**Application by Frodsham Solar Ltd for Frodsham Solar (EN010153)**

**The Examining Authority's second written questions and requests for information (ExQ2): Issued on 13 March 2026**

**Responses are due by deadline 5: 26 March 2026**

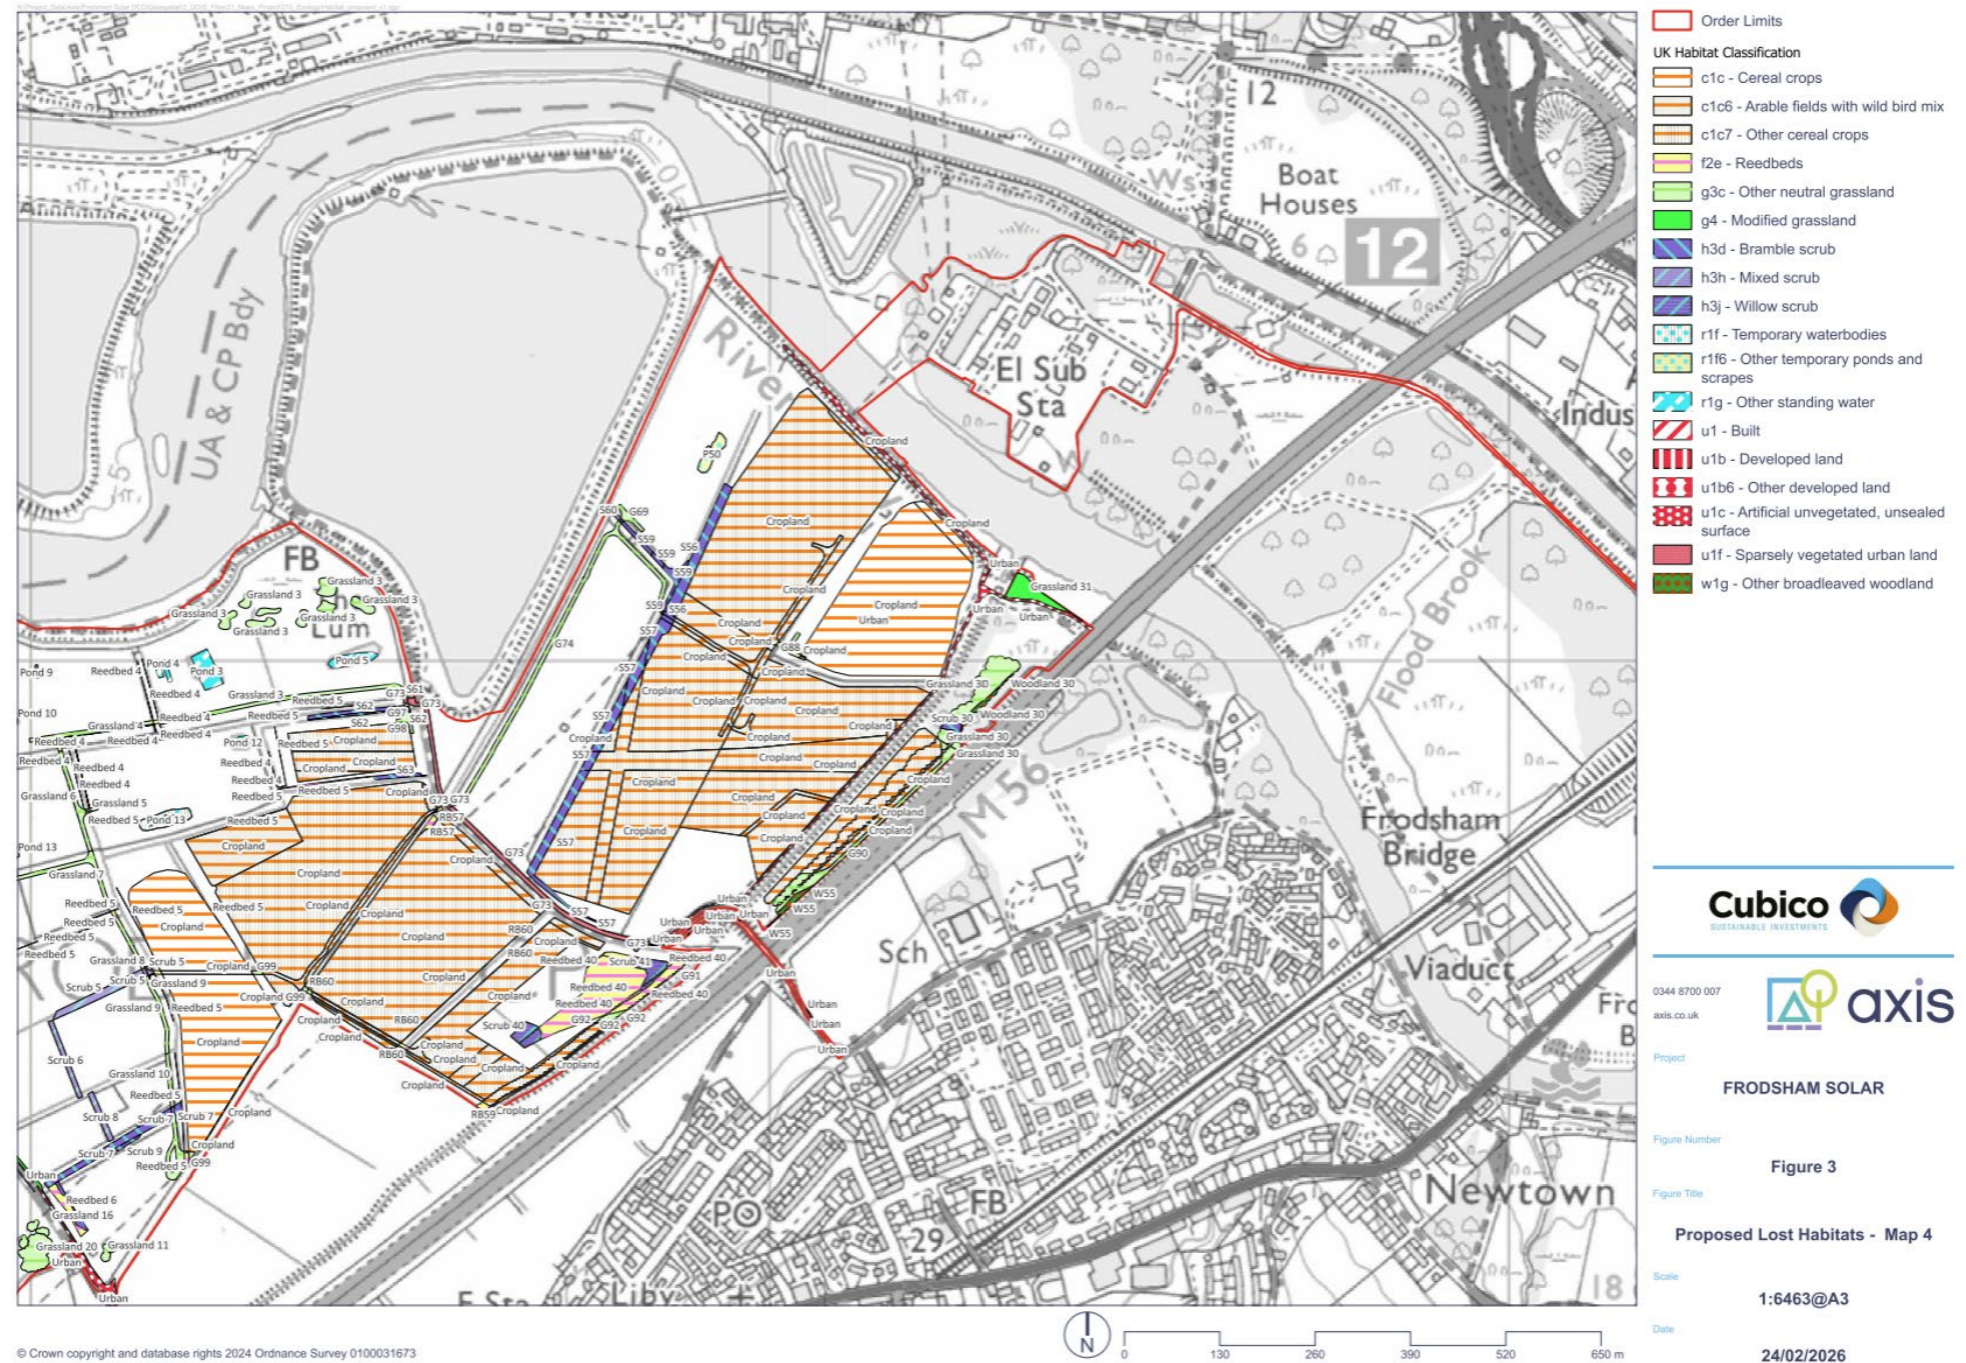
- 1) Can the applicant explain why post development there would be an increase in reedbed area but a decrease in reedbed units? What is it about the properties of the post development reedbed area that cause the calculation of resulting BNG units to fall?
- 2) The ExA acknowledges that BNG requirements are not yet mandatory for NSIP applications and that the applicant has clearly stated that the trading rules for reedbeds are not proposed to be met. Nevertheless, the mitigation hierarchy should still be adhered to. The ExA would like the applicant to explain how much reedbed is proposed to be lost for each of the areas given below and provide justification as to why these areas of reedbed are proposed to be lost and not retained:
  - a. Reedbed 12 shown in the NBBMA (see screenshot below from Map 2 of Figure 3 of the deadline 4 Biodiversity Net Gain Report [REP4-038])
